FINAL ENVIRONMENTAL IMPACT STATEMENT

DISPOSAL OF HANFORD DEFENSE HIGH-LEVEL, TRANSURANIC AND TANK WASTES

DECEMBER 1987

This comment volume has been prepared in compliance with Council of Environmental Quality (CEQ) regulations that provide for the consideration of comments received during the agency and public comment period (40 CFR 1503.4 & 1506.6). This volume contains responses by the Department of Energy (DOE) to approximately 2000 written comments included in 243 letters that were received by the DOE during the public comment period and to comments received during four public hearings conducted in July 1986.

FIGURE 1. Flow Diagram for Treatment of Public Comment Letters

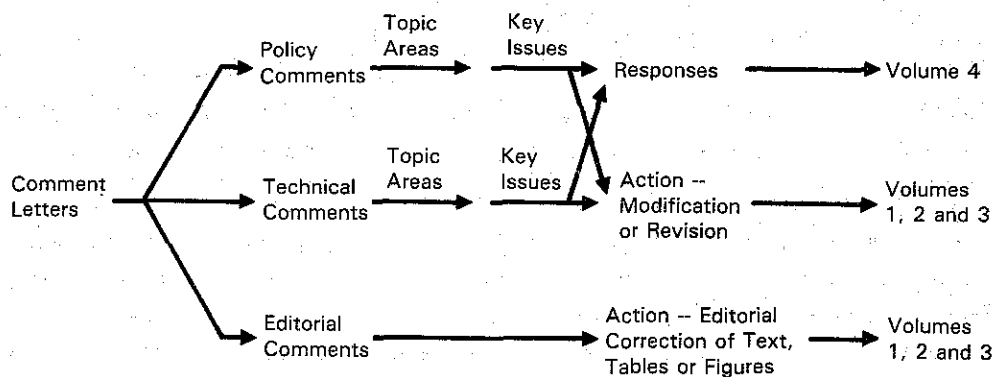
Figure 1 shows how the comments were handled from receipt to inclusion in the final EIS Volumes 1, 2, and 3, or this Volume 4.
